Access Compliance Report

Public Rights-of-Way

Intersection ID: 19216	Main Street: RAMA_RD	Cross Street: SARDIS_RD	Location: SW
ADA ID: 8CEECC1FCD60	Ramp Type: Perp	Initial Pass/Fail: Fail	Overall Compliance: No
		Severity Score: 12.5

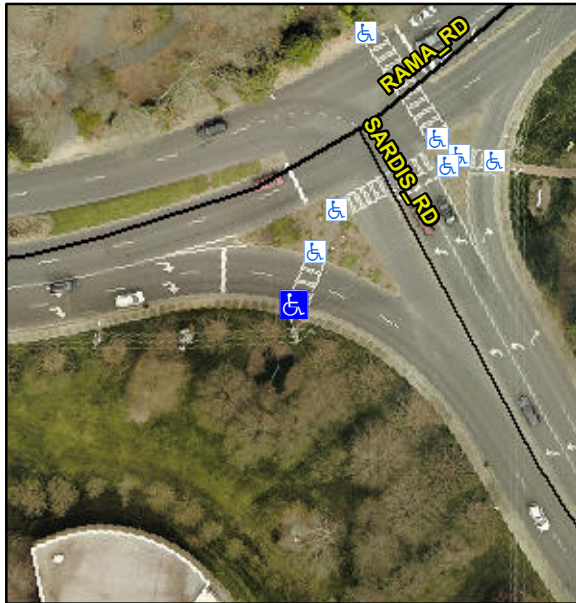
Not Found, R304.2.2

Compliance	Description	Data	Compliance	Description	Data
N/A	Ramp Length (in)	60.0	No	Ramp Slope (%)	8.4
Yes	Ramp Width (in)	48.0	Yes	Ramp XSlope (%)	0.2
N/A	Flare Type LT	N/A	N/A	Flare Type RT	N/A
N/A	Flare Slope LT (%)	N/A	N/A	Flare Slope RT (%)	N/A
N/A	Flare Traversable LT?	N/A	N/A	Flare Traversable RT?	N/A
N/A	Landing Length (in)	N/A	N/A	DWS Provided?	N/A
N/A	Landing Width (in)	N/A	N/A	DWS Contrast?	N/A
N/A	Landing Slope (%)	N/A	N/A	DWS Length (in)	N/A
N/A	Landing X Slope (%)	N/A	N/A	DWS Full Width?	N/A
N/A	Landing Curb? (Y/N)	N/A	N/A	DWS Offset (in)	N/A
N/A	Shared Landing?	N/A			
N/A	Gutter Ponding?	N/A	N/A	Gutter Slope (%)	N/A
N/A	Gutter Lip Ht (in)	N/A	N/A	Gutter X Slope (%)	N/A
N/A	Painted X Walk1?	Yes	N/A	Painted X Walk2?	N/A
	X Walk 1 Direction	To NE		X Walk 2 Direction	N/A
N/A	X Walk 1 Width (in)	113.0	N/A	X Walk 2 Width (in)	N/A
	X Walk 1 Slope (%)	2.2		X Walk 2 Slope (%)	N/A
	X Walk 1 X Slope (%)	0.5		X Walk 2 X Slope (%)	N/A

Remove & Replace Entire Ramp.
